Subject: Request for permission to implement modifications in 10 passenger locomotives (BRC & LGD).

Annexure 1 – Details of Hardware modification

Annexure-1

Fault code 40 " Main circuit breaker: status is not plausible"

Above Picture shows during the simulation time were the opening time of Main Circuit breaker is more than 400ms

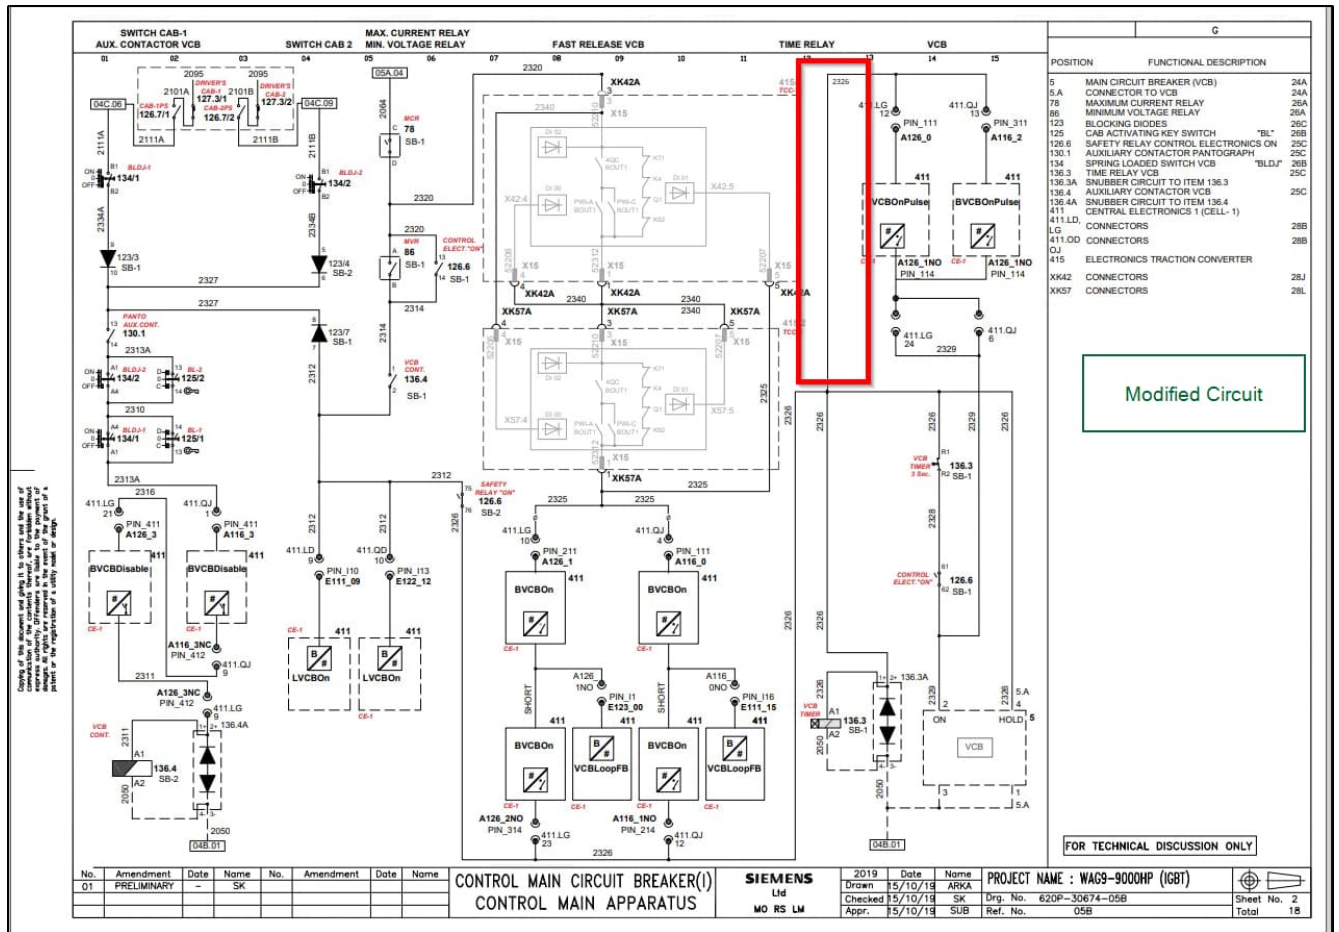
VCB opening time is monitored by ICU 's which is 400ms. During the simulation it was observed that if any of the ICU's of both traction converter sees any error will immediately commands VCB to open, but still the VCB is in closing transition state. This was causing the VCB opening time beyond 400ms and PWI assuming VCB could not able to open due to some reason and PWI's are taking protection by blocking the pulses and no traction was allowed there after till the TCU's are reset.

Modified Circuit Drawing in locomotive control circuit.

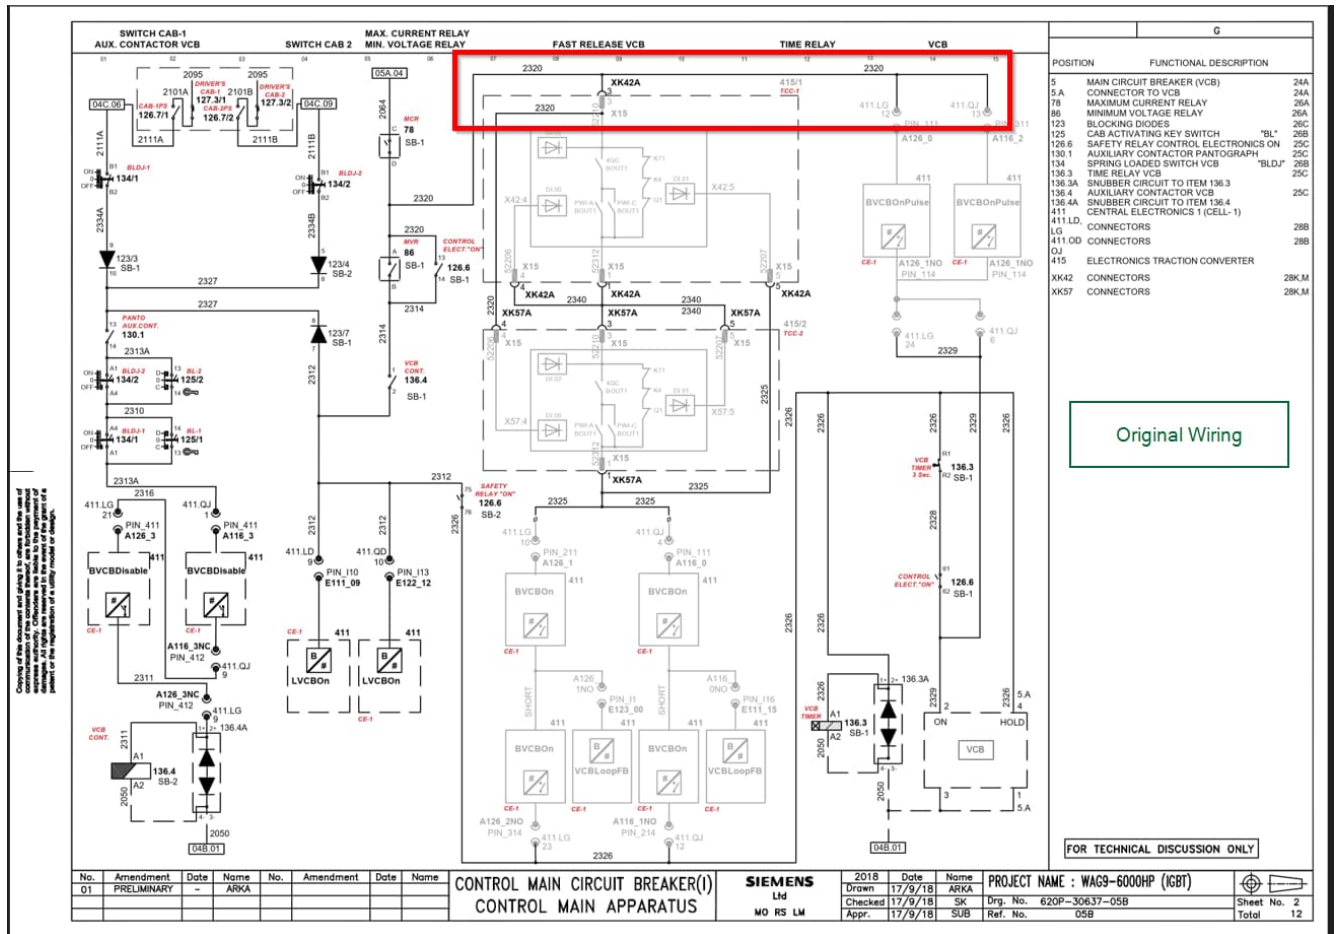
To synchronize the ICU 400ms below mentioned changes in wiring modification done. Common supply of BVCBON is given in BVCBONPULSE so that ON supply to VCB will also be get OFF if any ICU's opens VCB with in 400ms. This will keep the opening time below 400ms and FC 40 will be not seen by TCU-MCU.

Original (existing) Wiring in locomotive control circuit.

SB1 Back panel cable modification for BVCBOnPulse Do input for Existing loco in shed.				
Sr. no.	Existing Cable ID		Existing location	
1	2320-411.LG-12 / XF22S:03-37		XF22S:03-37	
2	2320-411.QJ-13 / XF22S:03-37		XF22S:03-37	
	New Cable ID for cable		cable to remove From location	Cable to connect at
1	2326-411.LG -12		LG-12 -XF22S:03-37	XF22S:03-58
2	2326-411.QJ -13		QJ-13 - XF22S:03-37	
	New cable to add		from location	To location
1	2326-411.LG -12		XF22S:03-58	XF22S.01-8
2	2326-411.QJ -13			XF22S.01-8
	Material required	quantity		
	0.5mm cable	2-3 m.		
SB1 Back panel cable modification for BVCBOnPulse Do input for New Commissiooning Loco.				
	Existing Cable Ferrule		New Cable ferrule and location	
1	2320-411.LG-12 / XF22S:03-37		2326-411.LG-12 / XF22S.01-8	
2	2320-411.QJ-13 / XF22S:03-37		2326-411.QJ-13 / XF22S.01-8
